Subject: U.S. Department of Energy Office of Legacy Management Response to U.S. Nuclear Regulatory Commission Letter Dated July 21, 2017, New Rifle, Colorado, Processing Site – Request for Additional Information RE: Draft Groundwater Compliance Action Plan (Docket No. WM-00062)

Request for Additional Information Draft Groundwater Compliance Action Plan New Rifle, Colorado, Processing Site Docket No. WM 00062

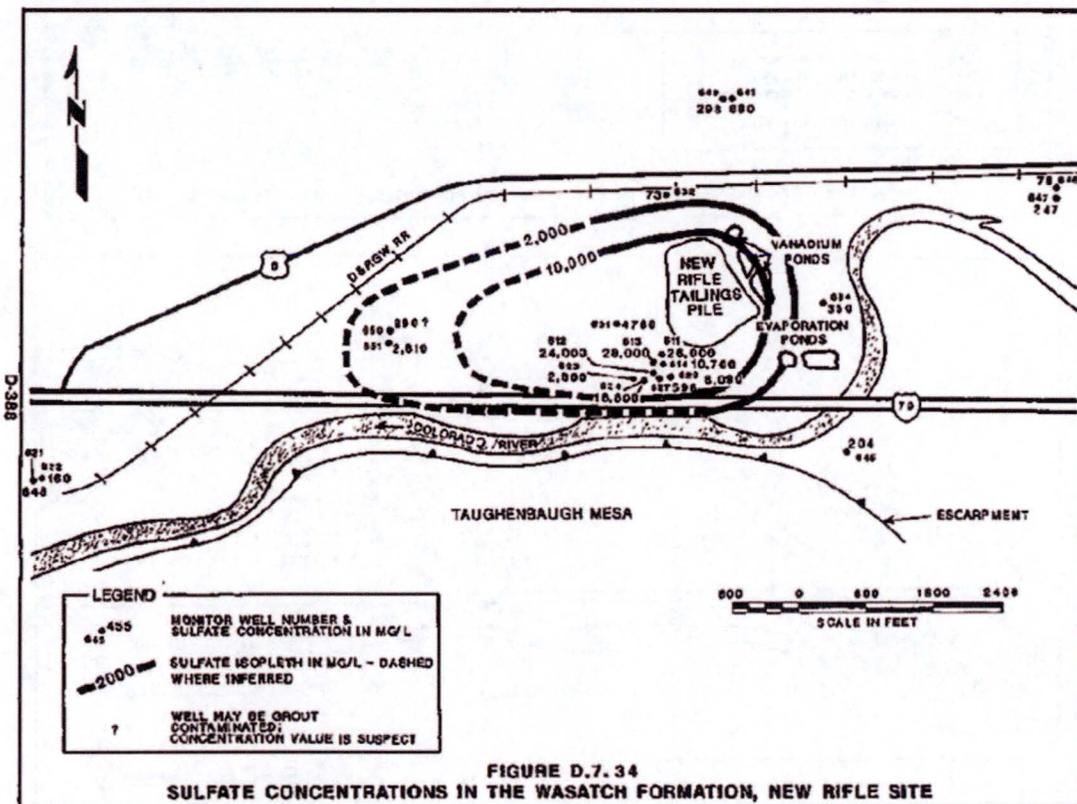
NRC Comment 6: The groundwater model and associated geochemical analyses do not have sufficient accuracy to support the argument that the POE can be limited to the Roaring Fork ponds, and monitoring at the western edge of the institutional control zone is not necessary. The previous DOE GCAP strategy of natural flushing is being revised because model predictions of natural flushing are unlikely to be achieved. Though that modeling has been shown to be inaccurate, new modeling is used to support the revised GCAP strategy. Without additional model validation, other actions may be necessary to account for uncertainty in the modeling.

- **Path Forward:** Provide additional technical basis to support the assumption that all contaminated water will discharge into the Colorado River prior to reaching the western edge of the IC zone, or provide a risk assessment demonstrating the adequacy of the ACL's if contaminated water at the point of compliance (POC) were to be transported out of the IC zone and used for normal purposes. Establish a monitoring point at the western edge of the IC zone to verify the assumption that contaminated water will not exit the IC zone.

DOE Response 6: It is important to clarify that the draft GCAP does not contain new modeling, such as numerical or analytical simulations of groundwater flow and contaminant transport. Rather, the document simply presents an updated assessment of the conceptual model of groundwater processes occurring at the New Rifle site, and this new assessment is not part of a strategy to address potential issues with previous numerical modeling.

DOE realizes that currently available data are not sufficient for supporting detailed technical evaluations that demonstrate that all contaminated water will discharge to the Colorado River prior to reaching the western edge of the IC zone. The limited number of wells west of the Roaring Fork Ponds and their wide spatial distribution are not conducive to the determination of local flow directions using methods such as flow net construction. DOE will continue to manage the New Rifle site and downgradient areas using the existing IC area. In addition, the GCAP states that monitoring will continue at the two westernmost wells at the site, 0620 and 0172, and at wells 0195 and 170, located west of the gravel pits. As discussed in the GCAP, the water chemistries at wells 0620 and 0172 appear to be impacted by processes that are completely different from westward migration of mill-generated contaminants in groundwater (DOE 2016), resulting in slightly elevated concentrations of dissolved constituents, including uranium. Nonetheless, uranium concentrations at both wells are less than 0.067 mg/L, the background concentration determined from groundwater sampling east of the Old Rifle site, suggesting that uranium in the westernmost part of the IC area is generated by naturally occurring processes in Wasatch Formation sediments north of the floodplain.

Figure 4. "Geologic Cross Section of the New Rifle Site," Figure 5-9 from the Site Observational Work Plan (DOE 1999)

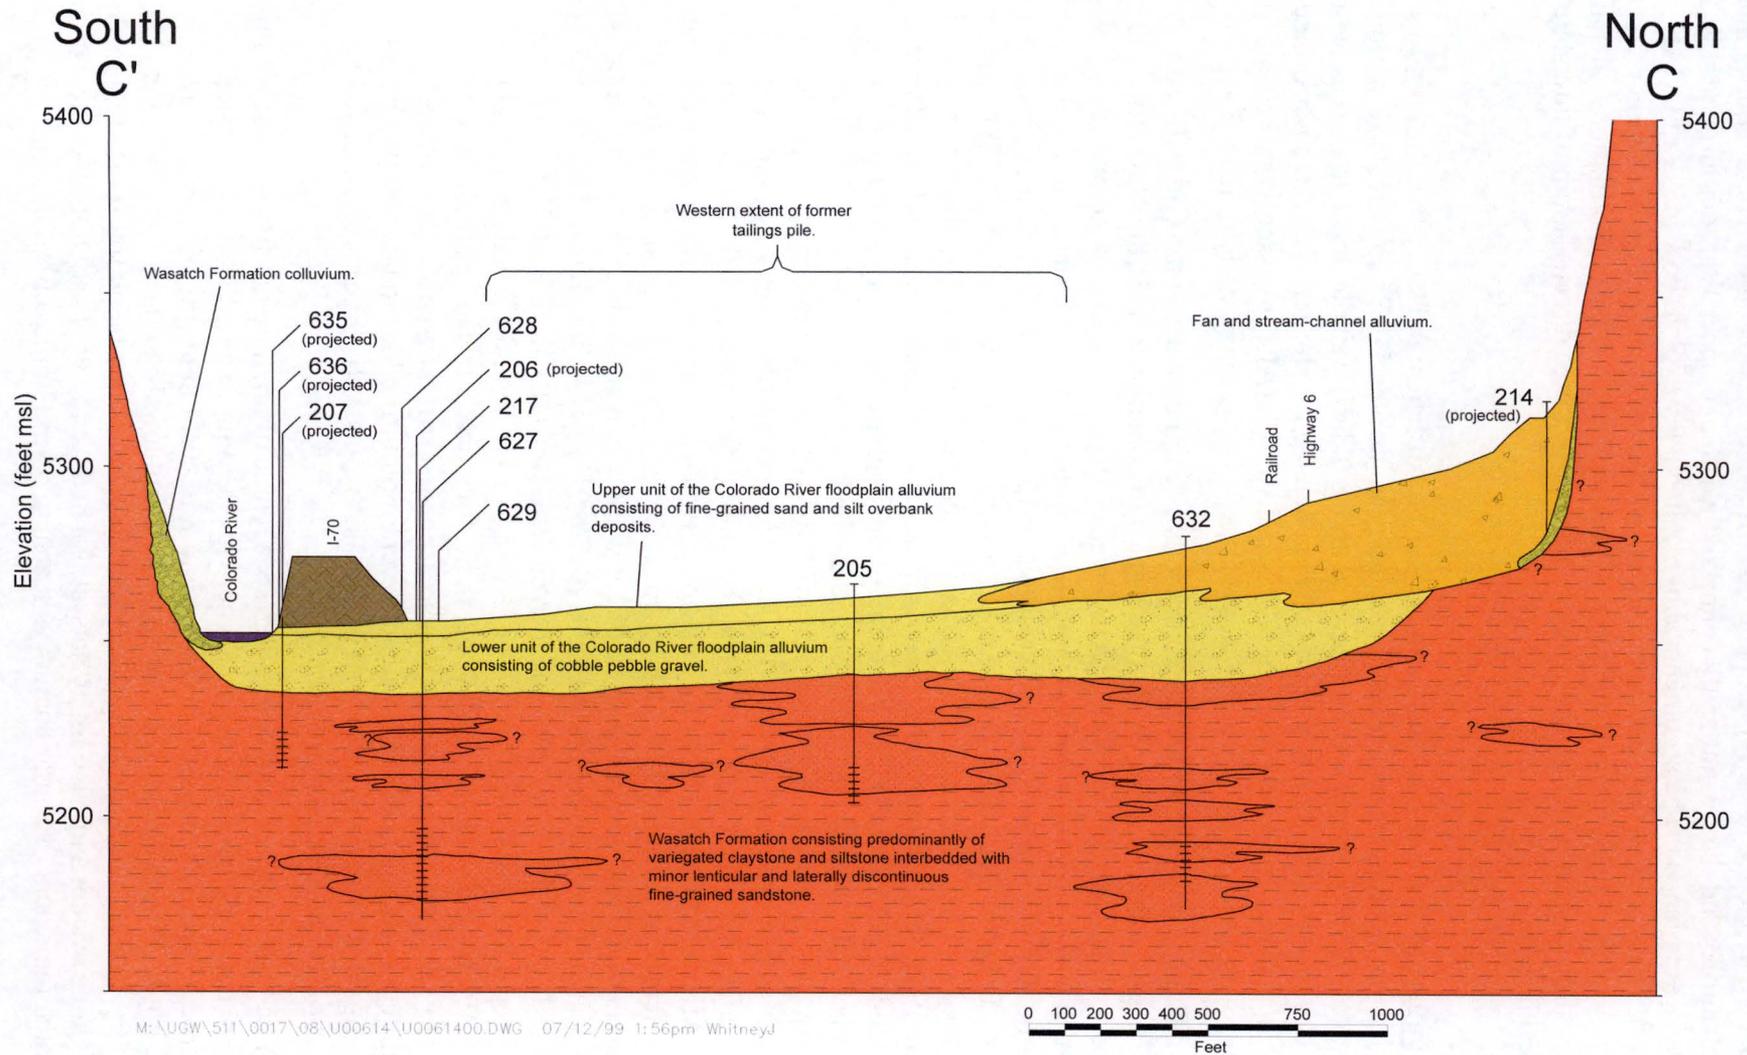
NRC Comment 7: DOE indicated that site field investigations have shown that the alluvial aquifer is the only aquifer affected by the former milling operations (page 15). This conclusion seems to contradict previous characterization data.

- **Path Forward:** Provide a description of monitoring data collected for the Shire and Molina Members of the Wasatch Formation. Reconcile the characterization data presented in the 1992 remedial action plan with the present day GCAP summary. If necessary, revise the monitoring network, and POE locations and analysis to account for contamination of the Wasatch Formation.

The hydrogeology of the New Rifle site can be used to explain why a new POE location in the Wasatch Formation south of Interstate 70 is not practical. The Colorado River, with very large flows in comparison to the groundwater flows beneath the New Rifle site, is an exposure medium for all contamination migrating south from the site. As discussed in the current draft GCAP, the Colorado River acts as a regional sink, capturing all groundwater flow on both sides of and from beneath the river, including all flow in the Shire member of the Wasatch Formation as well as from the alluvial aquifer. As described in the SOWP (DOE 1999), the dilution provided by the flowing surface water reduces the contaminant concentrations in groundwater discharging from the site to levels that are indistinguishable from background river concentrations. Thus a POE well screened in the Wasatch Formation just several tens of feet north of the north bank of the river, which coincides with the south boundary of the IC area, would be monitoring contaminant levels that are almost immediately reduced to non-risk levels in the river.

With the Colorado River acting as a regional sink, it is unrealistic for any contaminated groundwater to flow under the river from the New Rifle Site to the south side of the river, in either the alluvium or the Wasatch Formation. This can be seen in the attached Figure 5-9 from the SOWP (DOE 1999), which shows a north-south cross section extending from the south border of the Taughenbaugh Mesa on the south side of the river Prefontaine Mesa north of Highway 6. As depicted in this figure, the thin layer of alluvium underlying the river is terminated on the south side of the river where it abuts against Wasatch Formation sediments.
